ITEM FOR ENVIRONMENTAL BOARD AGENDA

NAME & NUMBER OF PROJECT: Carriage Crossing Section 2 Lot 1 Resubdivision
C8J-2010-0117.0A

MEMORANDUM

SUBJECT: Carriage Crossing Section 2 Lot 1 Resubdivision
C8J-2010-0117.0A

Map of CEFs, CEF Setbacks, Proposed Driveway Alignment, Slopes, CWQZ, and WQTZ

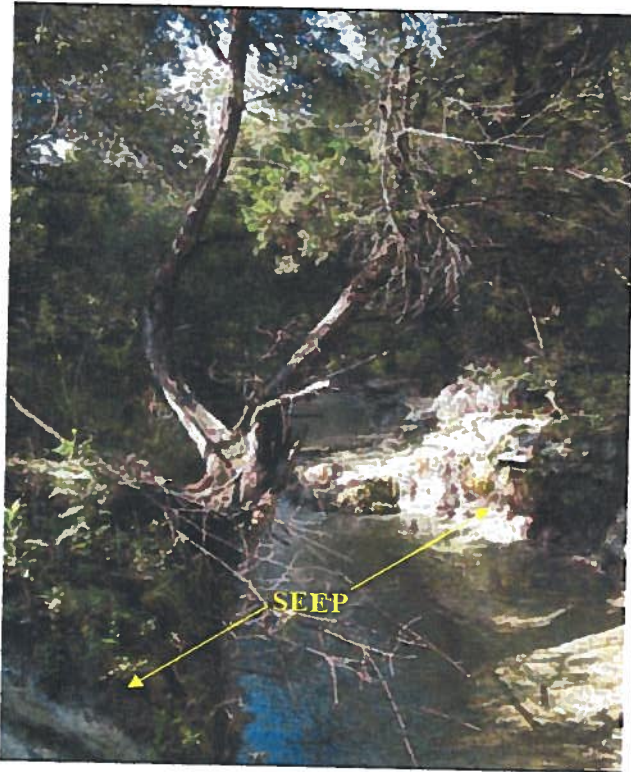
Each of the 3 proposed lots includes a buildable area of 0.8 acres to 0.9 acres located in the Uplands Zone and on slopes ranging from 0 to 15%. However, accessing the proposed Lots 2 and 3 would require construction of a driveway on slopes ranging from 0% to approximately 38%. The applicant has proposed a lot configuration that would provide for a single driveway to be utilized by the owners of each of the 3 proposed lots (Exhibit 4 – Proposed Resubdivision). In contrast to multiple driveways, a single driveway would reduce the construction on slopes in excess of 15%. Additionally, the driveway alignment avoids ECM Appendix F trees with a diameter of 19 inches and greater (Exhibit 5 – Tree Survey).

On September 15, 2010, ACI Consulting scientists conducted a field investigation within the property in accordance with the City of Austin Land Development Code to locate Critical Environmental Features. Critical Environmental Features are defined by the Land Development Code as features that are of critical importance to the protection of environmental resources, and include bluffs, canyon rimrocks, caves, sinkholes, springs, and wetlands. Two Critical Environmental Features were identified (Exhibit 6 – Site Photographs). One seep (Critical Environmental Feature - CEF 1) and one wetland (Critical Environmental Feature - CEF 2) were identified. Both are located within the Critical Water Quality Zone and Water Quality Transition Zone setbacks. In accordance with Land Development Code Section 30-5-281(C)(1)(a), a 150 foot buffer zone from the edge of each Critical Environmental Feature has been established (Exhibit 4 – Proposed Resubdivision).

The proposed driveway alignment shown in Exhibit 4 will be added to the resubdivision plat and shown as the only driveway alignment allowed for the property.
